**Subject: GSF Development Driller II**  
**Reference: Acceptance of Well Control Equipment**

WEST Report #3940

## Section 1: Executive Summary

Operator: BP  
Rig: *GSF Development Driller II*  
Contractor: Transocean  
Location: Mississippi Canyon 252 #2 Drill  
Water Depth: 5,134 feet  
Dates of Assessment: 14 May to 10 June 2010  
WEST Representatives: Greg Pennock and David Moore  
WEST In-House Technical Review: Tom Bishop  
WEST In-House Administrative Review: Stacia L. Brooks

**Figures 4.01 and 04.02:** Above shows the kill side auto choke gate (arrowed) and seat, both were found to be in excellent condition so the auto choke was re-assembled with new body 'O' rings and back up rings.

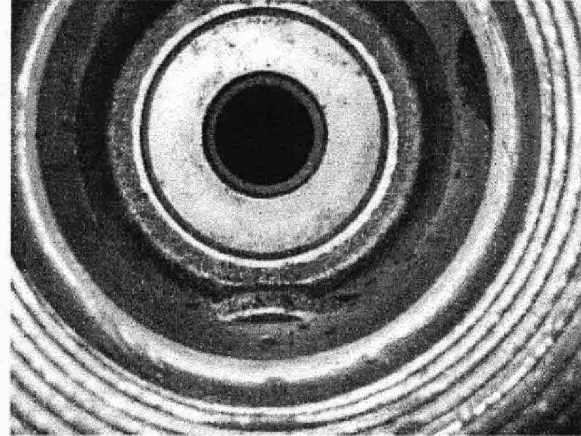
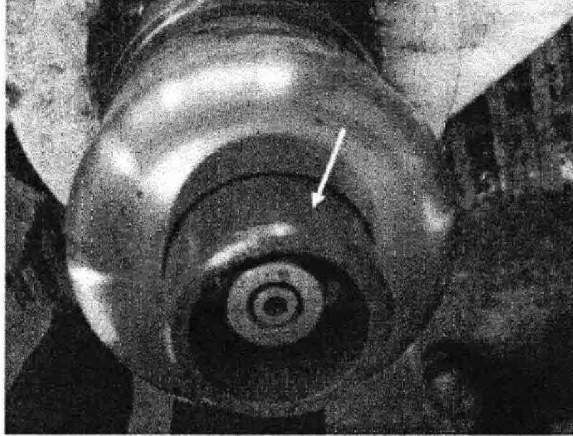
- The manual chokes, once removed, were both found to have severely damaged seats. There was one spare seat in the rig store, which was replaced, part # SW4233, in the choke side manual choke body. The rig has ordered a further seat to replace the kill side hot shot. See Figures 4.05 & 4.06 below. The gates were found to be in serviceable condition.

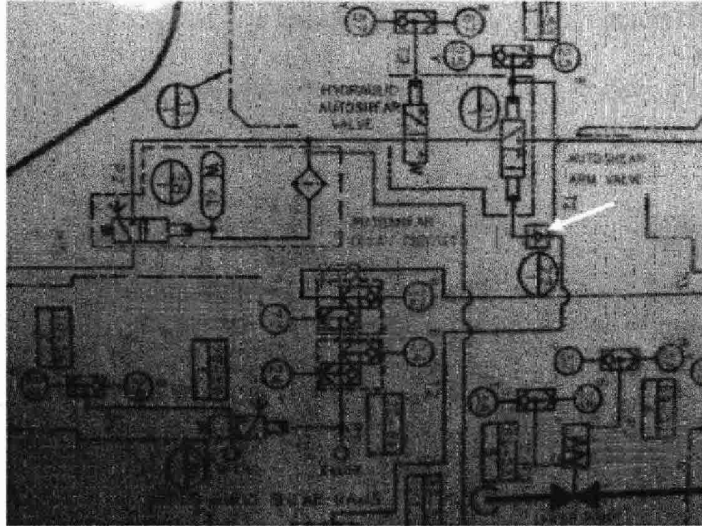
- The time delay circuit spring loaded accumulator, which was suspected as being the cause of the dead man/ autoshear system problem was stripped down for inspection. No anomalies were found with the accumulator so it was rebuilt and re-installed in the BOP auto shear time delay circuit.

**Figure 12.01:** shows part of the auto shear circuit hydraulic schematic. The arrow indicates the POCV which is included in the circuit to keep a positive 'arm' pressure on the autoshear arm valve, when the pilot pressure to the 'arm' side of the valve is lost, i.e. in a dead man/auto shear situation. From testing with hotlines to the pilot side of the 'arm' valve it was proved that if the POCV should leak and release the positive 'arm' pressure to the valve, the arm valve will begin to close and 'chatter', thus preventing correct operation of the auto shear system.

A. Attachment A & B: schematics of pod hydraulic modifications for the dead man system.

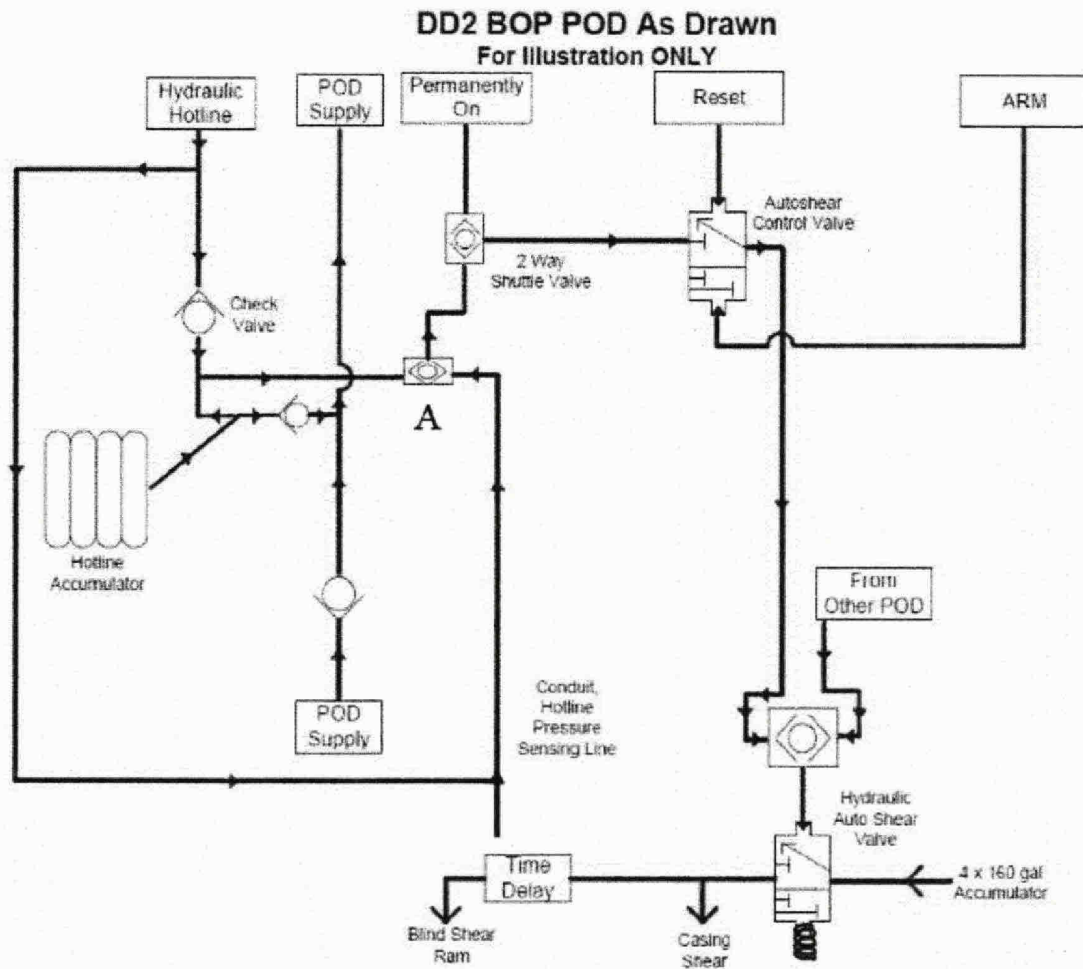
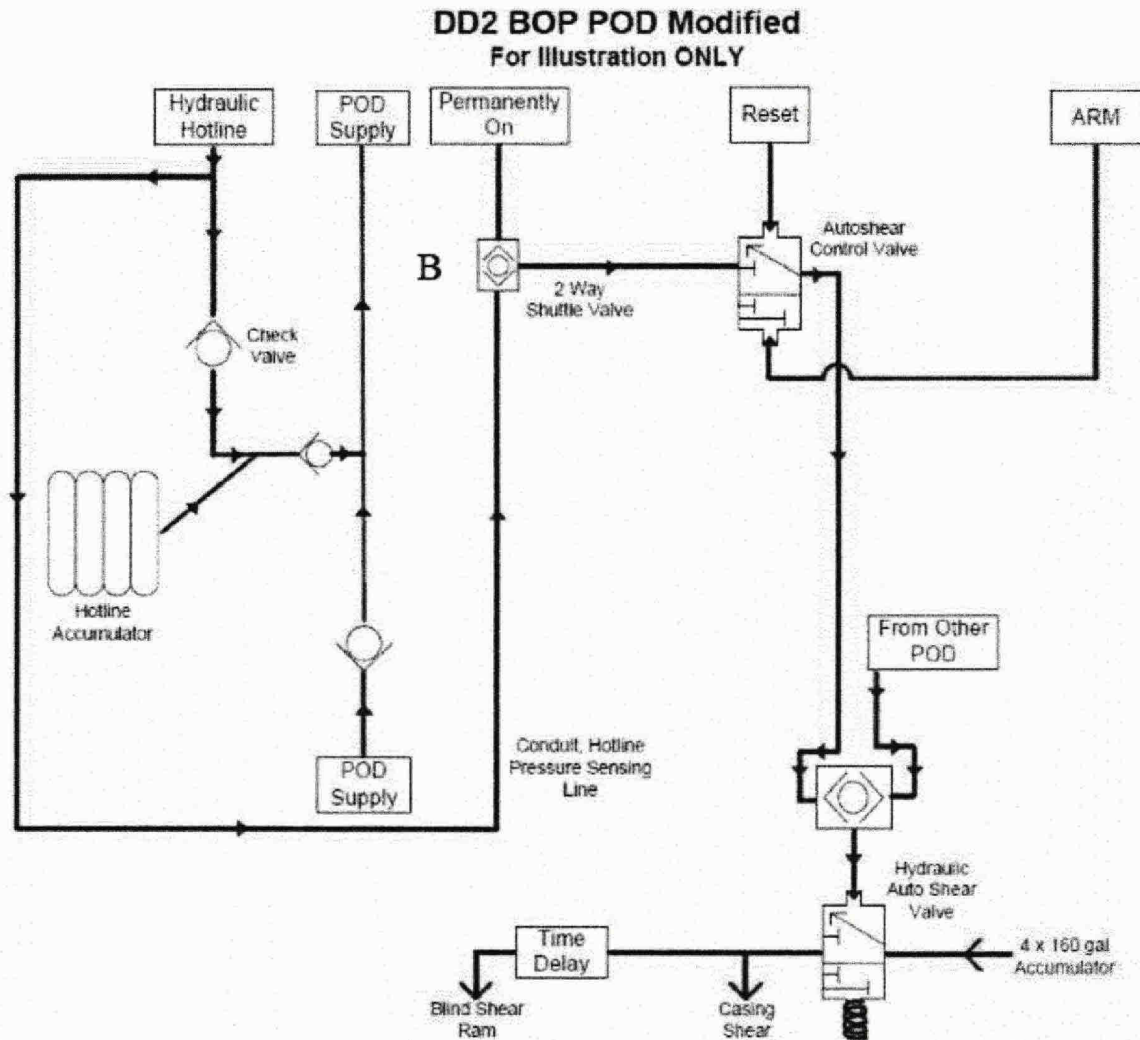
Attachment A shows the as built hydraulic schematic of the pods. Because of the position of the hotline pressure sensing take off below the check valve in the hotline supply, to shuttle valve A it would be impossible for the pilot pressure to the hydraulic auto shear valve to bleed off, due to the check valves in the system, accumulators etc, and activate the dead man sequence in case of a catastrophic failure of the riser system and loss of all hydraulic and electrical supplies.

Attachment B shows the hydraulic schematic after removal of shuttle valve A and attachment of the pressure sensing line directly into shuttle valve B. This will allow the system to operate as designed. The system was proved to function correctly after this modification.

**Figure 17.01:** Upper annular cap seal, also see Figure 17.02, being tested using a TAM packer before the BOP is run. This is one method of testing this seal during stump testing. The flex joint and flange connection to the upper annular are also tested using this method.

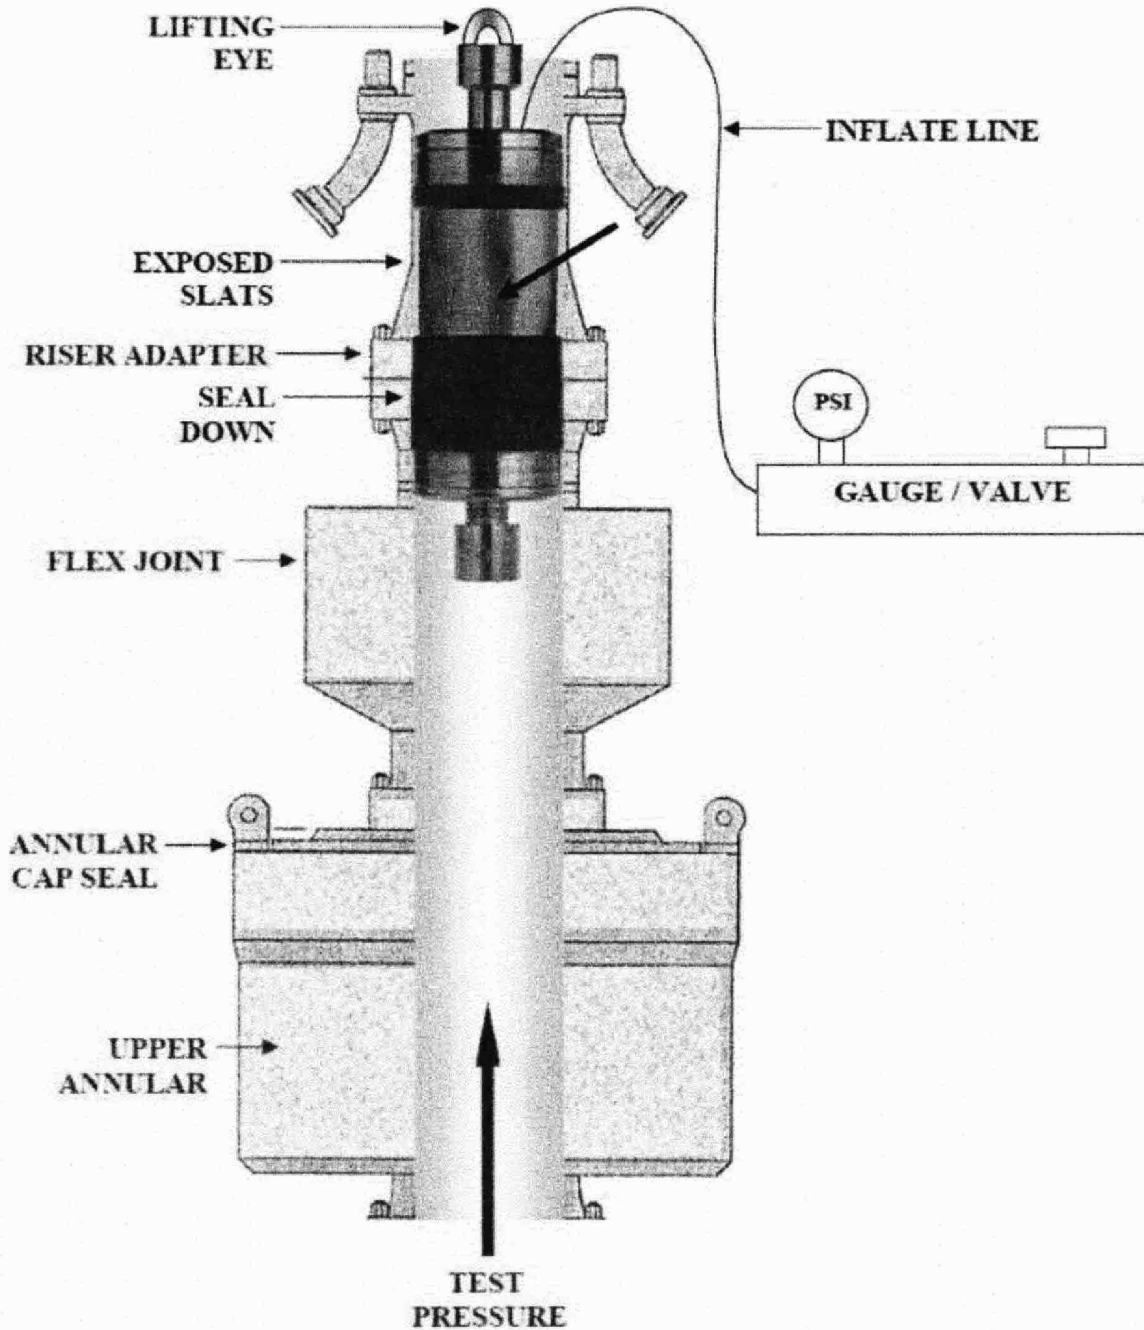
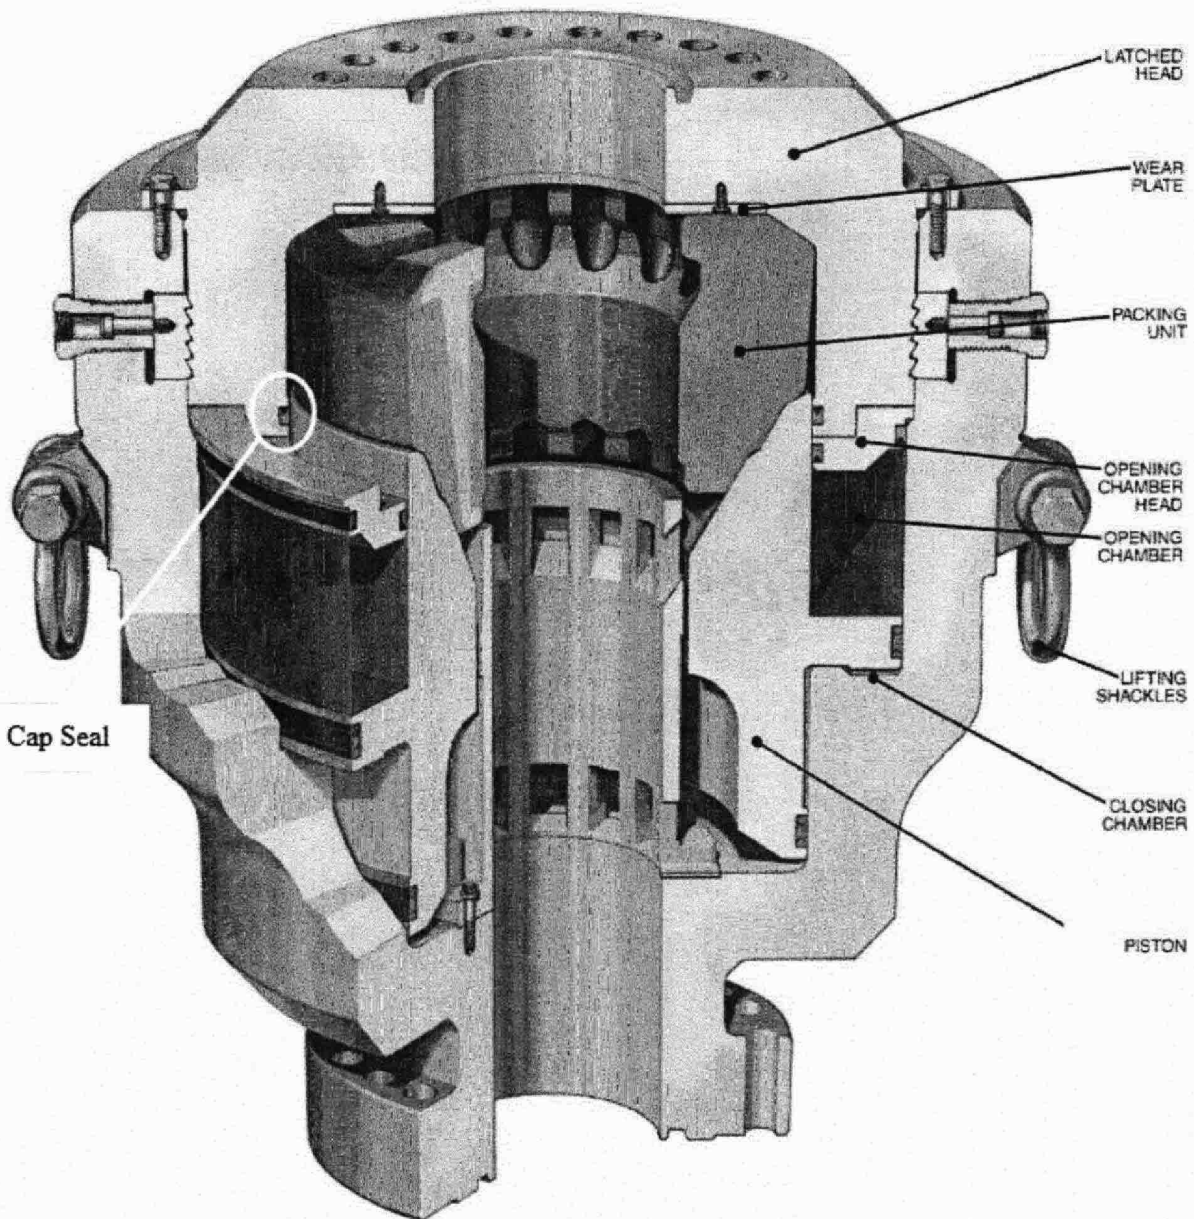
If the seal were to leak subsea, the only option would be to retrieve the LMRP to surface to affect a repair. See Figure 17.01 and 17.02 below.

**Figure 18.01:** This shows a typical MUX pod with ROV observable analogue gauges fitted for all critical functions

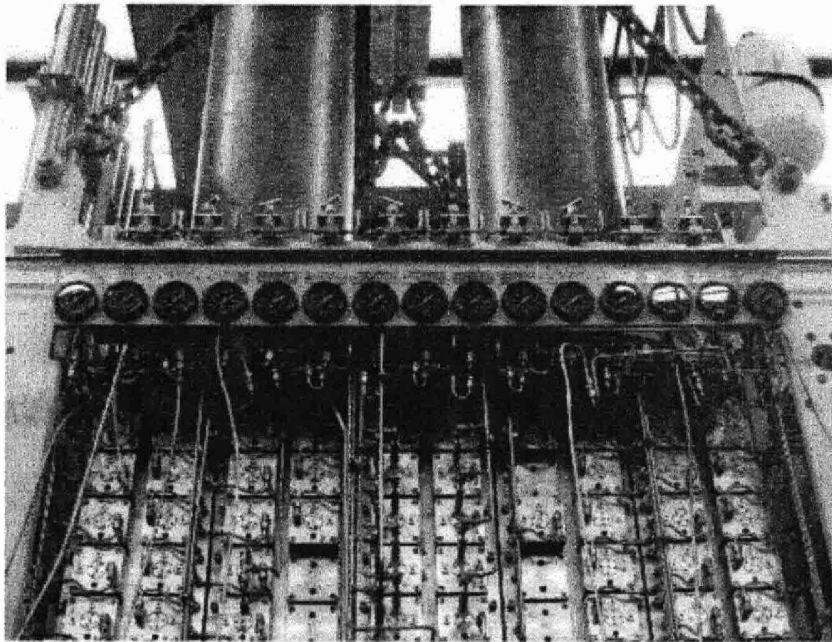
With reference to recommendation #3, the Hydril Controls MUX control pod relies solely on electrical pressure transducers to monitor the critical operating pressures within the pod. If any of these transducers were to fail subsea, there is no way of monitoring the pressures within the pod. Analogue gauges on the pod would allow the ROV to monitor critical pressures and ensure the pod was functioning correctly. This could avoid the need to pull the LMRP to effect repairs to the pod. See Figure 18.01, below.
